TECHNICAL SERVICE BULLETIN

VSB-06 Vanleigh Ambition Equalizer Replacement

Technical Service Bulletin VSB-06 Repair Instructions

Models Involved: 2022 and 2023 Vanleigh Ambition 5th wheels RV's

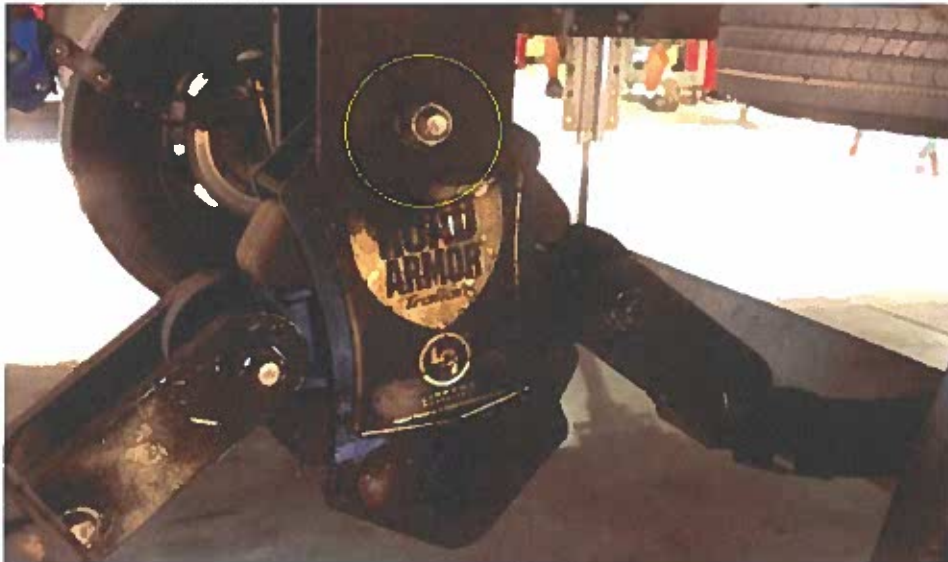
It has come to our attention that Vanleigh Ambition 5th wheel RVs were built with a double axle equalizer instead of a triple axle equalizer.

Tiffin Motorhomes will replace the double axle equalizer with a triple axle equalizer.

Purpose: To provide instructions on how to replace the double axle equalizer with a triple axle equalizer.

1. Lower leveling jacks and place jack stands under main frame I-beam to ensure unit is properly supported before performing any work.
2. Remove wheels from front and middle axle. Use floor jacks under the front axle and middle axle for support.

3. Use 7/8" – 1/2" drive deep well socket to remove front and middle wheels from unit.
